SALT WATER CORROSION on TRANSMISSION ELECTRIC SHIFT

(Attach Bulletin Reference Sticker to New P. 7C-24 of Your Service Manual.)

MCM 225-TR and 255-TR Stern Drive Engines
MCM II-TR (Serial No. 3640148 and Below) WITH Power Steering
MCM II-TR (Serial No. 3562885 and Below) WITHOUT Power Steering
MCM 255 II-TR (Serial No. 3524331 and Below) WITH Power Steering
MCM 255 II-TR (Serial No. 3523800 and Below) WITHOUT Power Steering

**Figure 1. Nuts and
Cap Screw Locations**

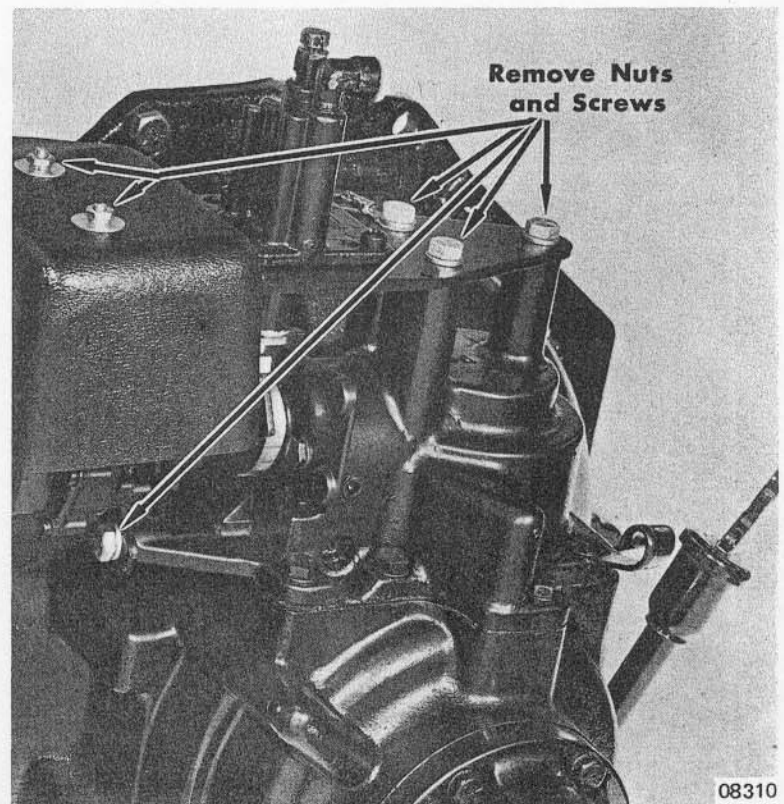
1. Disconnect the ground cable from the battery.
2. Remove the cap screws and nuts as shown in Figure 1.

Figure 2.
Lubricating
Components

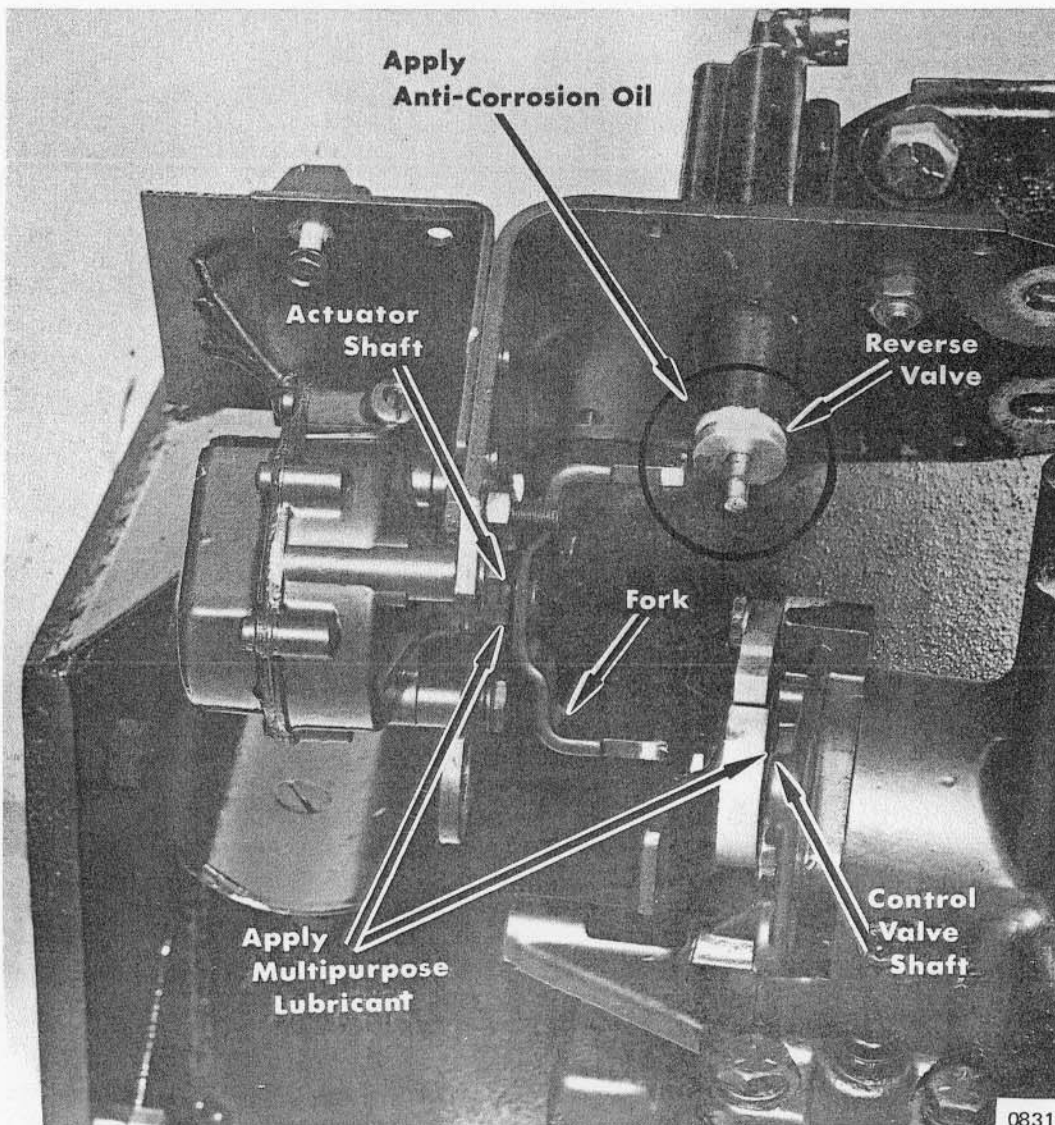
3. Tilt actuator and bracket forward as shown in Figure 2.
4. Clean salt deposits from plunger end of reverse lock assembly and apply a coat of Anti-Corrosion Oil (C-92-39928) on area shown in Figure 2.
5. Clean salt deposits from electric shift actuator shaft and from control valve shaft and apply a liberal amount of Multipurpose Lubricant (C-92-49588 or C-92-63250) to completely fill the space between end of motor housing and fork of output shaft. Also use Multipurpose Lubricant to fill the space between cam for reverse lock valve and cover on transmission, as shown in Figure 2.
6. Reassemble shift actuator assembly to transmission and replace actuator cover.
7. Connect ground battery cable and test unit for shifting to be certain that lubricated parts are working freely.
